Humanetics Innovative Solutions, Inc.

TF-RUCC FLEX PLI TASK FORCE PRESENTATION

Comments BAsT/BGS

JANUARY 27, 2012

"NO GAP" CONDITION-CARRIAGE SKIRT CONTACTING BEARING RETAINER

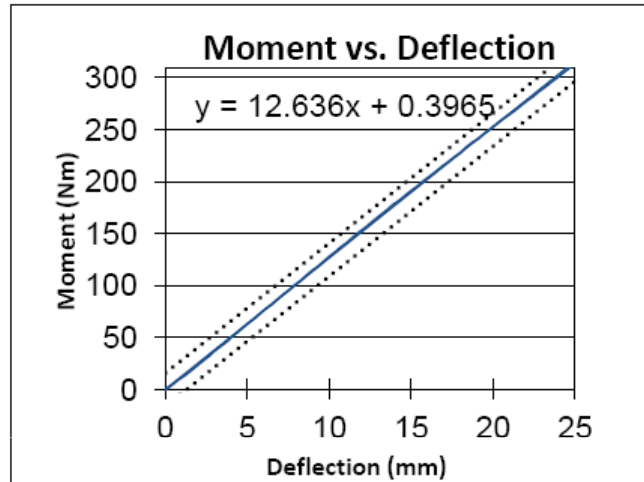
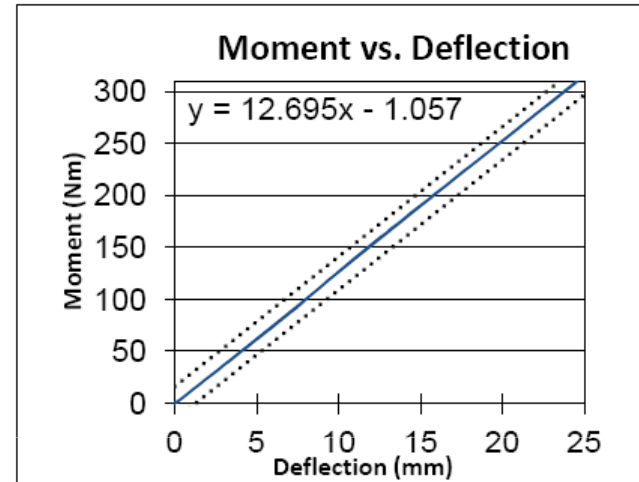
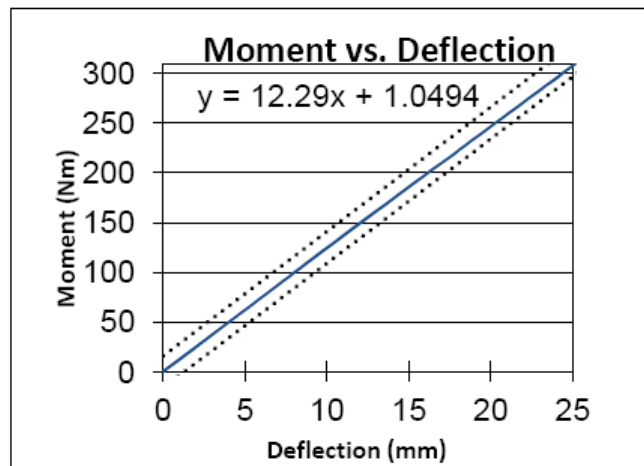
**Comment BAST/BGS:
„No gap“ test is unusual
calibration setup as it causes
unintended friction.**

Gap Condition-Carriage NOT Contacting Bearing Retainer

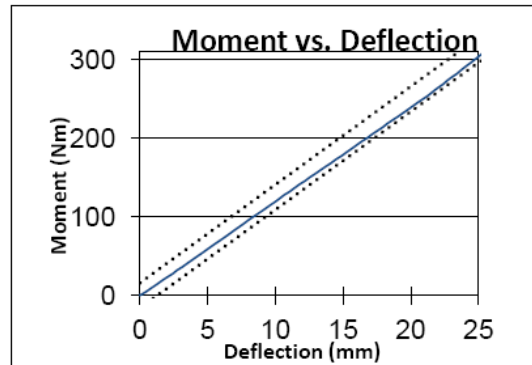
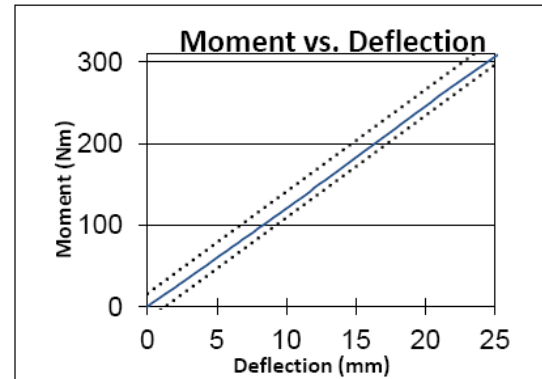
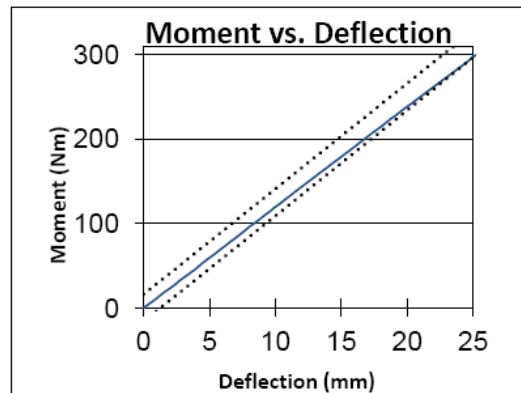
Comment BAsT/BGS:

Test more sensitive

- no friction
- higher degree of freedom
- higher influence of long bone properties
- higher values
- better assessment

Conclusion:

- Higher repeatability of „PE test“ no argument for type of test to choose
- Quite the contrary: PE test and „no gap“ test not sensitive enough
- ➔ „With gap“ test needed as calibration test !

TEST 4: NO GAP; SHIFTS CURVE TOWARD UP IN CORRIDOR

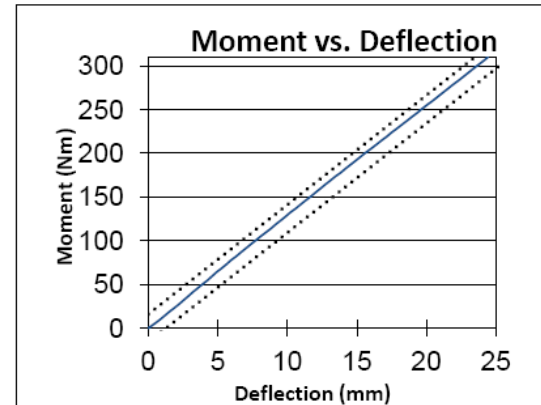
Of course !

„No gap“ test setup causes unintended friction !
